REMARKS

1. Amendments to Specification, Abstract, Drawings, and Claims

AMENDMENTS TO DRAWINGS

Fig 1 (Prior art)

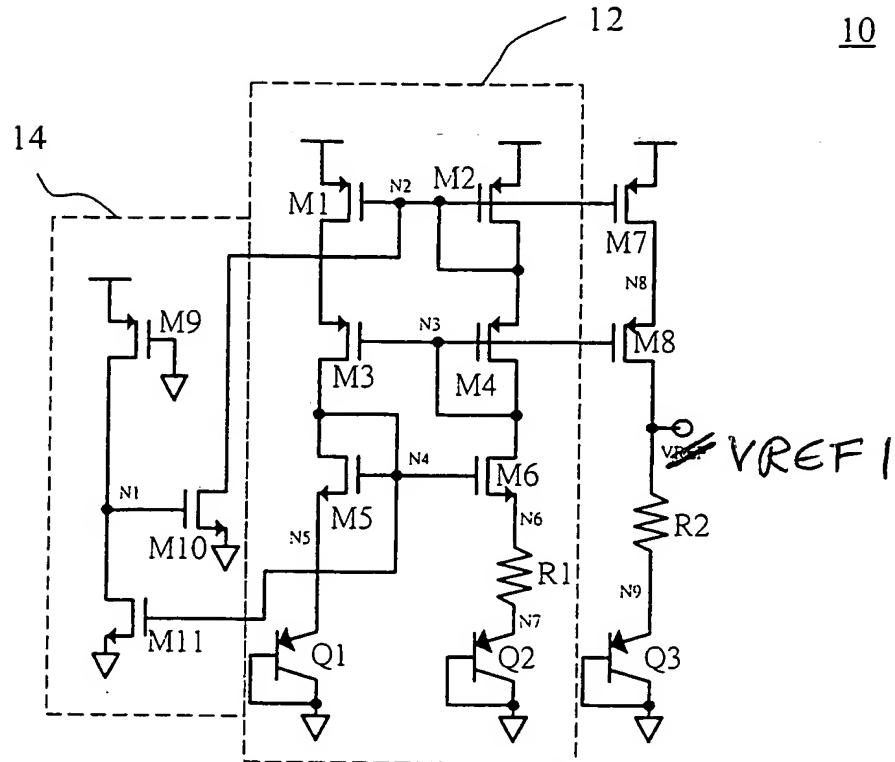
Figs. 1-4 have been amended by correcting the output voltage designator VREF to read -VREF1- (Fig. 1), -VREF2- (Fig. 2), and -VREF3- (Figs. 3 and 4) for consistency with the references thereto in the original specification.

Please amend Figs. 1-4 by changing "VREF" in each figure to, respectively, VREF1, VREF2, and VREF3, as indicated in the attached REPLACEMENT SHEETS and ANNOTATED SHEETS SHOWING THE CHANGES.
